Access Compliance Report

Public Rights-of-Way

(Pedestrian Signals)

Intersection ID: N/A	Main Street:	Cross Street: N/A	Location: N/A
ADA ID: D34CE5ECC6EA	Signal Type: One Push Button-APS	Overall Compliance: No	Severity Score: BTN 1: N/A BTN 2: N/A No BTN: N/A
Codes/Mitigation Info/Possible Solution		Field Measurements/Component Compliance

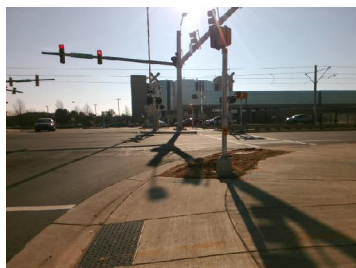
Possible Solutions: Remove & Replace
Replace APS Button With New APS Button.
Remove and Replace Clear Space.

PROW/ADA: R404.2, R404.3, R404.7.2,
R209.1, MUTCD 4e.10

N/A	B 1 FWD Approach Width (in)	N/A	N/A	B 2 FWD Approach Width (in)	N/A
N/A	B 1 FWD Approach Obstruction?	Yes	N/A	B 2 FWD Approach Obstruction?	N/A
N/A	B 1 FWD Approach Obstruction Dist (in)	4.0	N/A	B 2 FWD Approach ObstructionDist (in)	N/A
N/A	B 1 PARA Approach?	Yes	N/A	B 2 PARA Approach?	N/A
N/A	B 1 PARA Approach Constrained?	Yes	N/A	B 2 PARA Approach Constrained?	N/A
Yes	B 1 PARA Approach Reach (in)	10.0	N/A	B 2 PARA Approach Reach (in)	N/A
No	B 1 PARA Approach Width (in)	48.0	N/A	B 2 PARA Approach Width (in)	N/A
N/A	B 1 PARA Approach Obstruction?	Yes	N/A	B 2 PARA Approach Obstruction?	N/A
N/A	B 1 PARA Approach Obstruction Dist (in)	4.0	N/A	B 2 PARA Approach ObstructionDist (in)	N/A
No	B 1 Clear Floor Space Slope (%)	3.9	N/A	B 2 Clear Floor Space Slope (%)	N/A
No	B 1 Clear Floor Space XSlope (%)	4.3	N/A	B 2 Clear Floor Space XSlope (%)	N/A
N/A	B 1 PAR Slope (%)	N/A	N/A	B 2 PAR Slope (%)	N/A
Yes	B 1 Height (in)	40.0	N/A	B 2 Height (in)	N/A
